**DESIGN/DEVELOPMENT REVIEW COMMISSION
DESIGN REVIEW DISTRICT
HISTORIC CONSENT AGENDA
EVALUATION SHEET
Case #3**

ADDRESS: 17 Gibbes Court

NATURE OF REQUEST: Request for preliminary certification for the Bailey Bill

SHEET TITLE
 Elevations

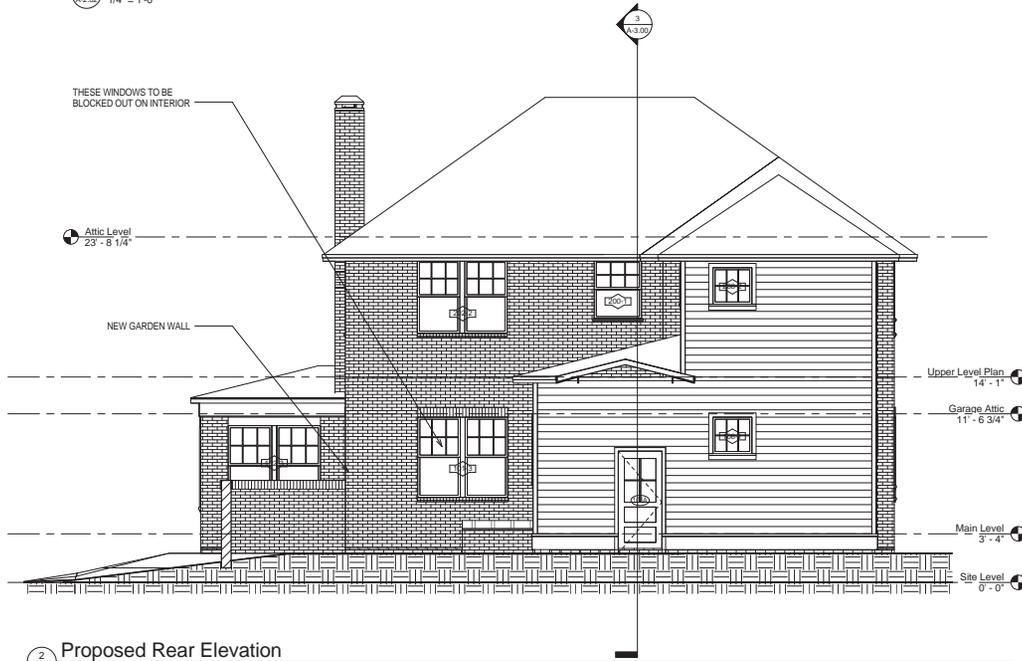
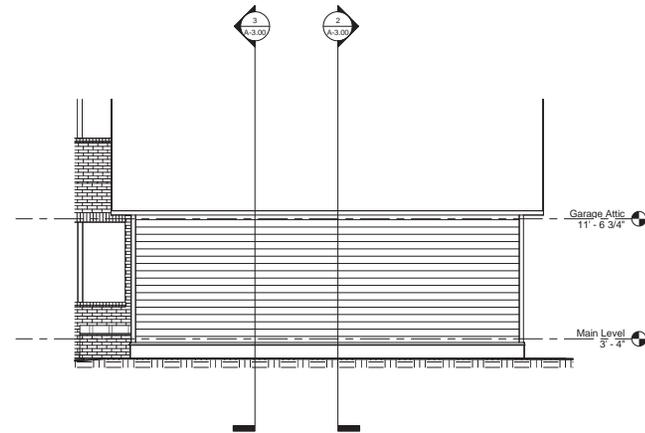
Chimneys: The elevations only show one chimney; however, the house has two brick chimneys. Staff recommends retaining, repairing and reflashing these chimneys as necessary.

Foundation: The elevations do not specify the material for the foundations of the addition or the garage. Staff recommends a brick foundation to match the existing historic brickwork, and a skirt board to be consistent with other wood sided buildings in the district.
